City of Portland, Maine - Building or Use Permit Application 389 Congress Street, 04101, Tel: (207) 874-8703, FAX: 874-8716

BUILDING PERMIT REPORT

REASON FOR PERMIT: Replace Porch add rear deck

7-3 Zone

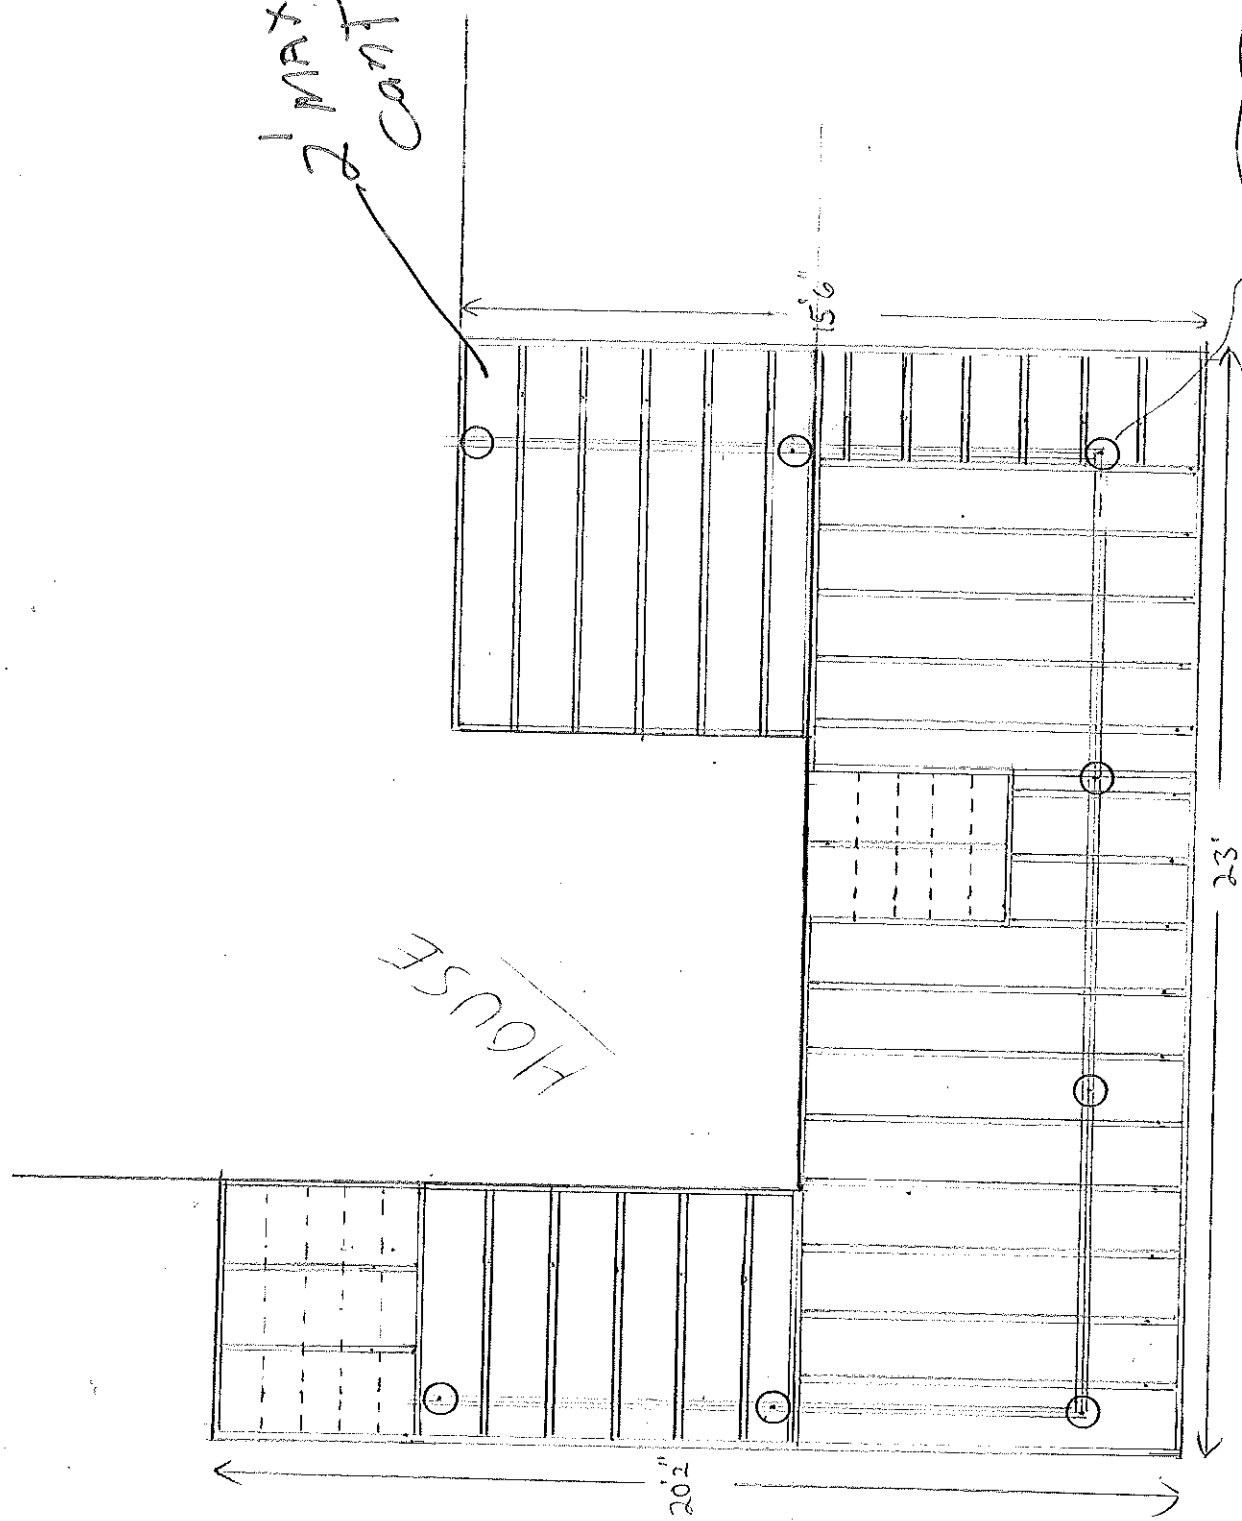
REAR: 25' req - 33.5' shown

Side: 8' req - 20' shown

Replacement of Existing Porch

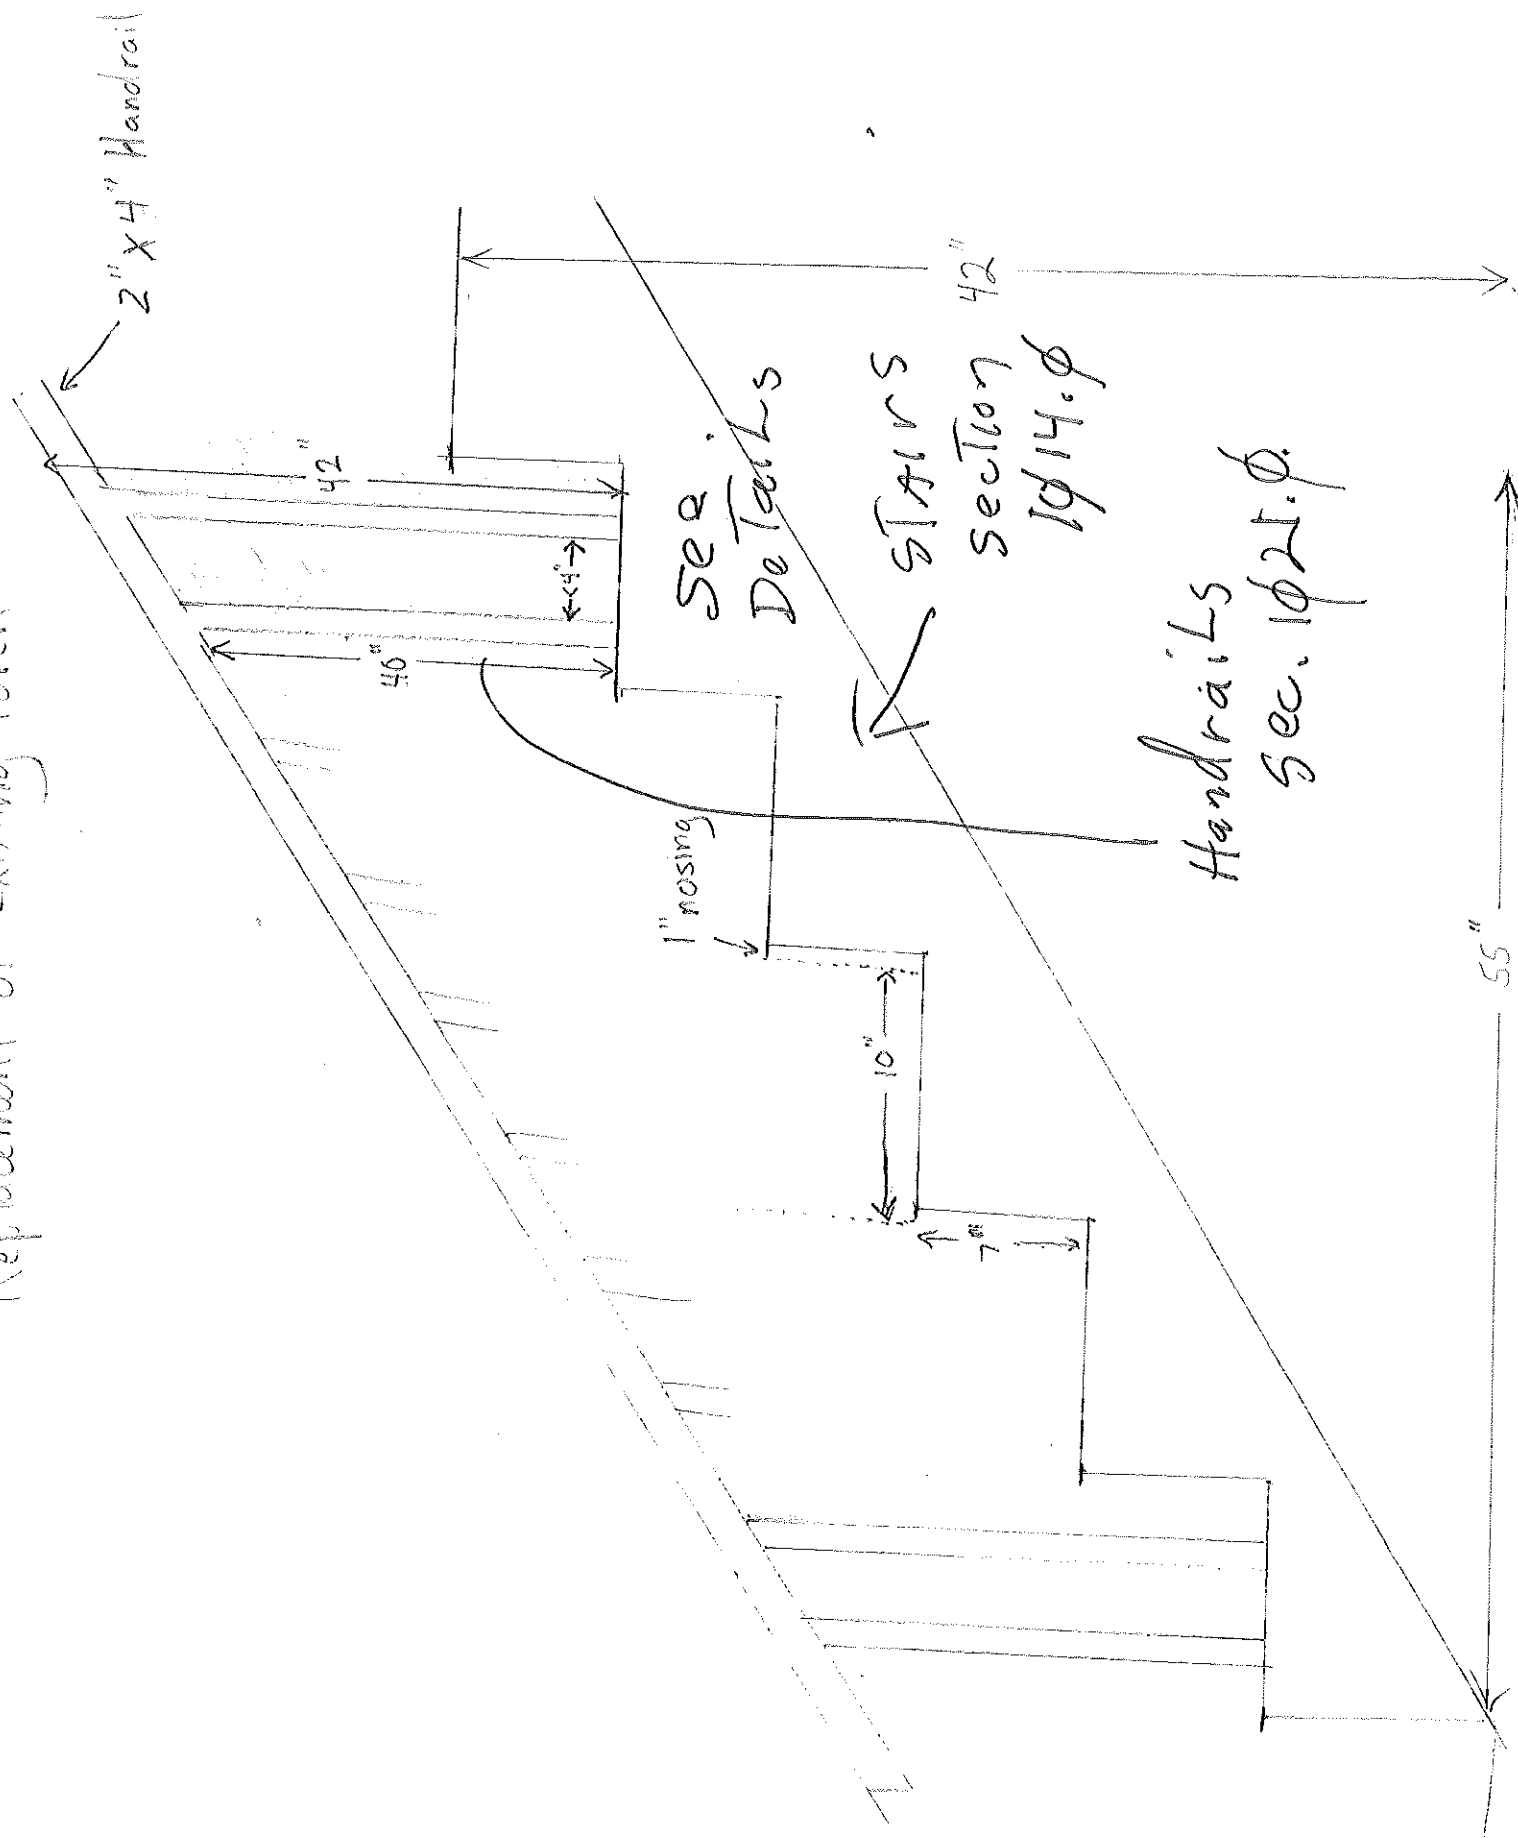
Guardraile
SEC. 2.0
4" APART

6x6 POST
P.T. ?
